STAFF REPORT FOR THE PLANNING COMMISSION MEETING OF JUNE 29, 2016

FILE NO: TPUD-16-053

REQUEST: To consider a request from State Street Development LLC (property owner: State Street Development LLC) for a Tentative Planned Unit Development to create 105 single family attached residential parcels, including a request for a reduction in perimeter setbacks, a reduction in the minimum lot size, the use of a modified parking standard, and a Special Use Permit to allow a residential use on property zoned General Commercial (GC), located at State Street, APN 002-441-23.

**Engineering Division
Planning Commission Report
File Number TPUD 16-053**

OPEN SPACE DATA

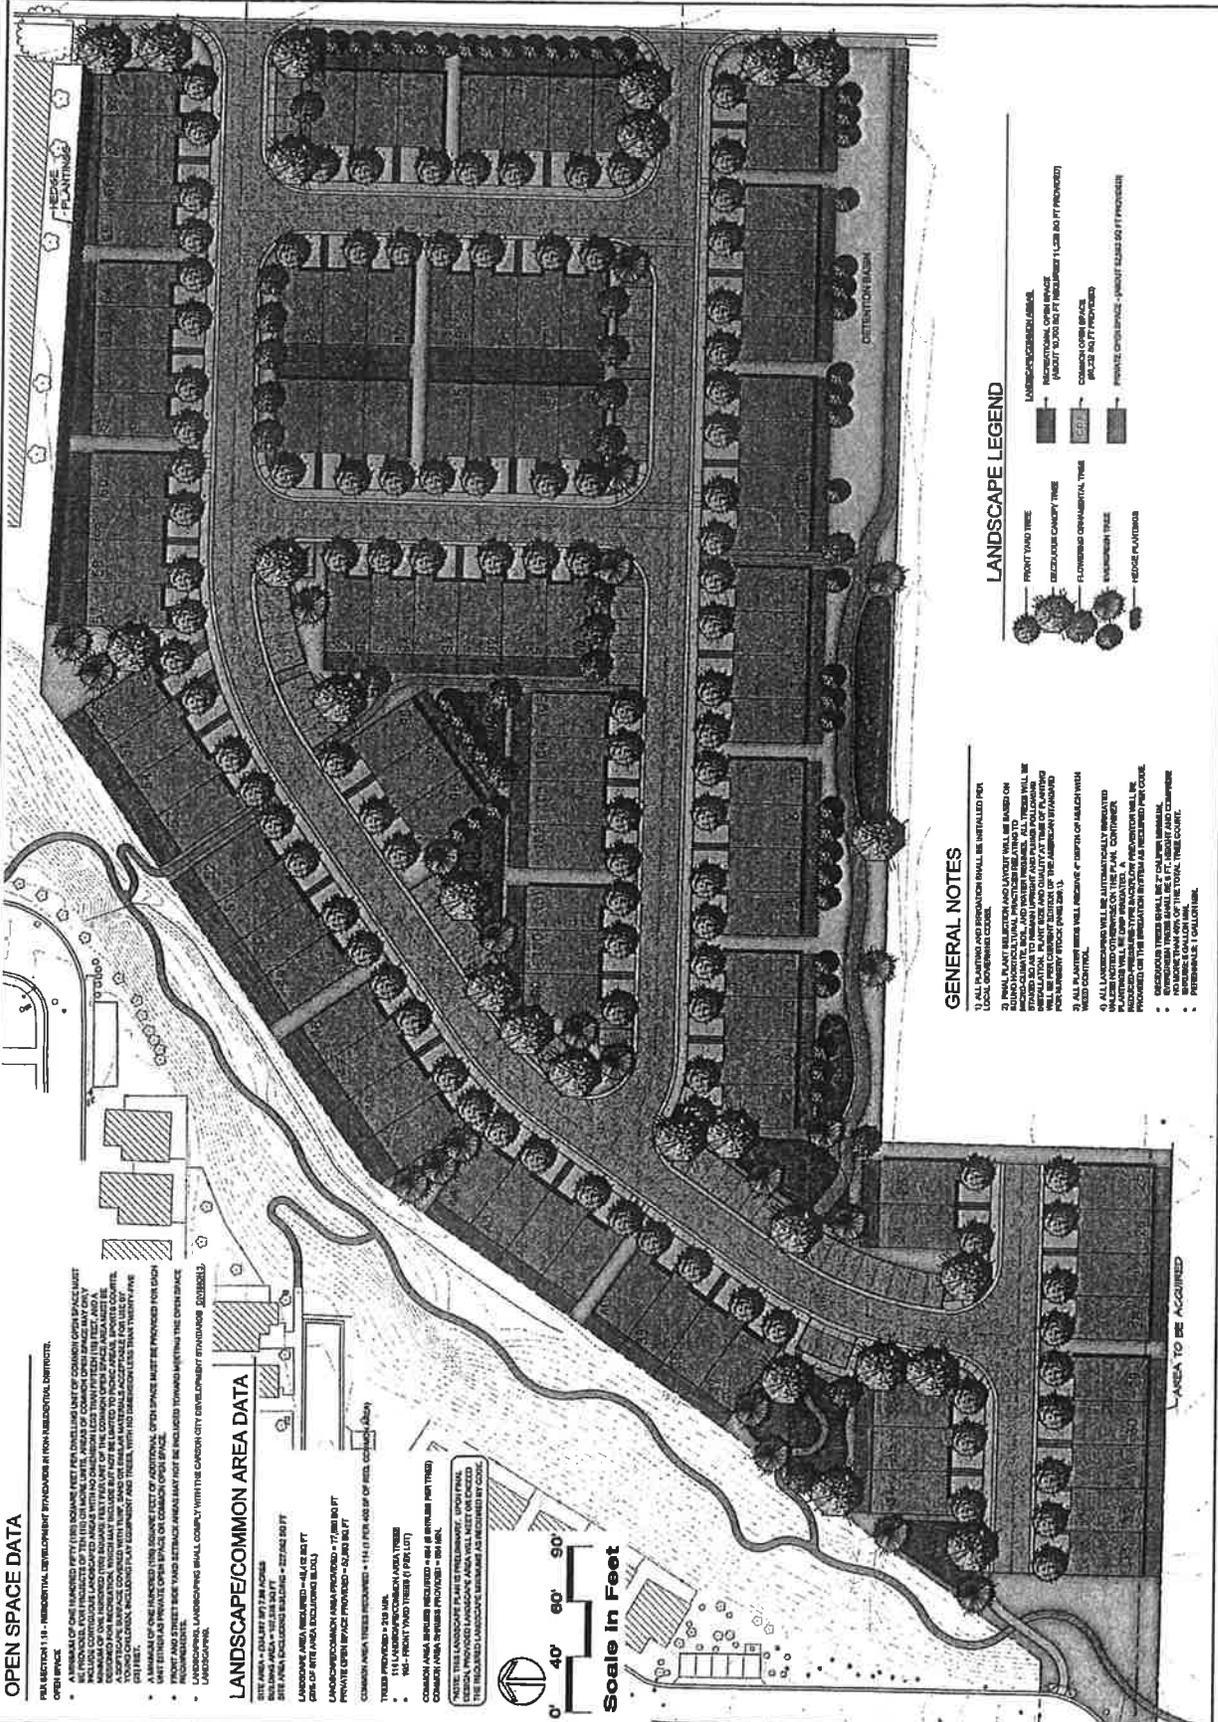
On page L1 of the plan set, the applicant has identified 66,232 square feet of common open space, whereas given 105 units, 15,750 square feet would be required to meet this requirement.

On page L1 of the plan set, the applicant has identified 52,593 square feet of private open space, whereas given 105 units, 10,500 square feet would be required to meet this requirement.

Given the total open space provided, staff believes that the proposed plan will meet the requirements. However, staff has recommended a condition of approval that the applicant provided a detailed derivation of the open space areas to supplement page L1 to verify compliance will all open space requirements.

14. A supplement to Page L1 detailing the derivation of all open space provisions and demonstrating compliance with City open space requirements must be submitted prior to issuance of any improvement plans.
